PROJECT: BROOKFIELD FRP PONTOONS
CUSTOMER: MILLER CONST. / VTRANS
SHEET: GALVANIZED STEEL FABRICATION

WEIGHT:	N/A
DESCRIPTION:	FABRICATION
SCALE:	1 : 6
WO NO.	8420
CONTRACT NO.	9185
DWG NO.	8420-7
SHEET	1 OF 1
PONTOON	N/A
PART NO.	N/A

Vermont Agency of Transportation
RECEIVED
ON: **June 30, 2014**
and Checked for
CONFORMANCE
BY: **Jennifer Fitch** DATE: **07/07/2014**

GALVANIZED SPLICE PLATE - SHORT

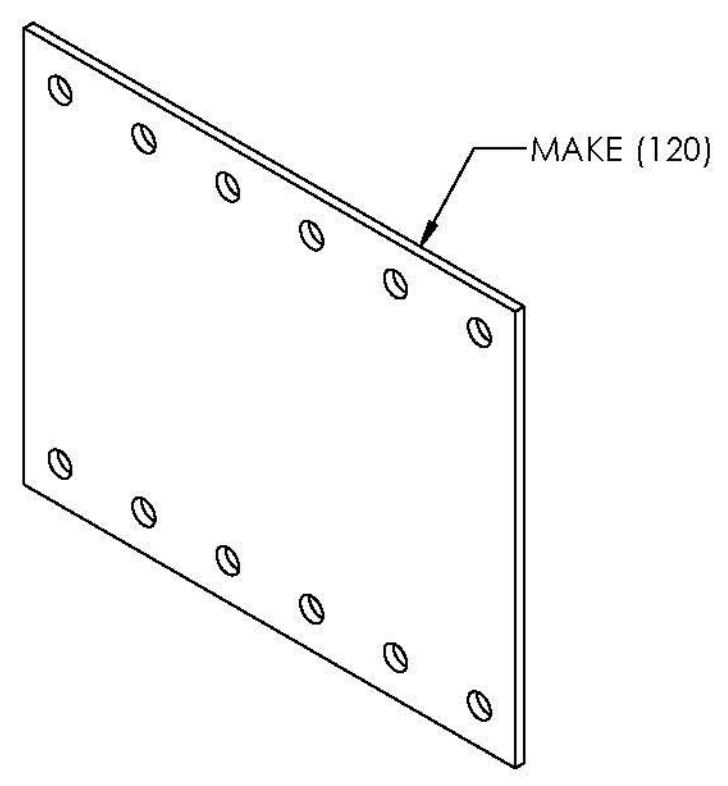
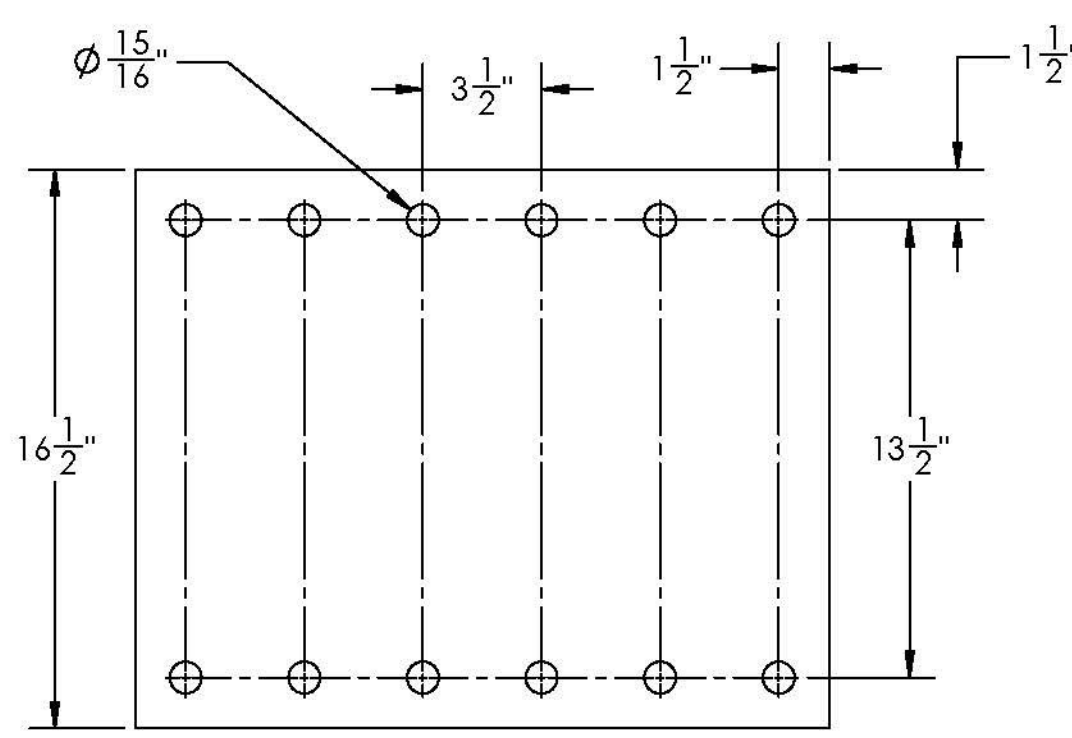
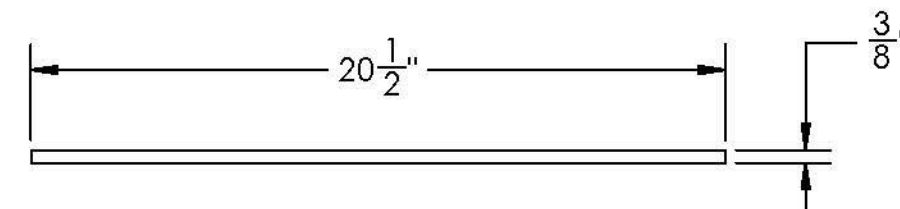
- STEEL HARDWARE SHALL MEET REQUIREMENTS OF ASTM A 325, TYPE I (7/8" Ø BOLTS THROUGHOUT) **THREADS OF BOLTS SHALL BE EXCLUDED FROM THE THICKNESS OF THE CONNECTED MATERIAL.**
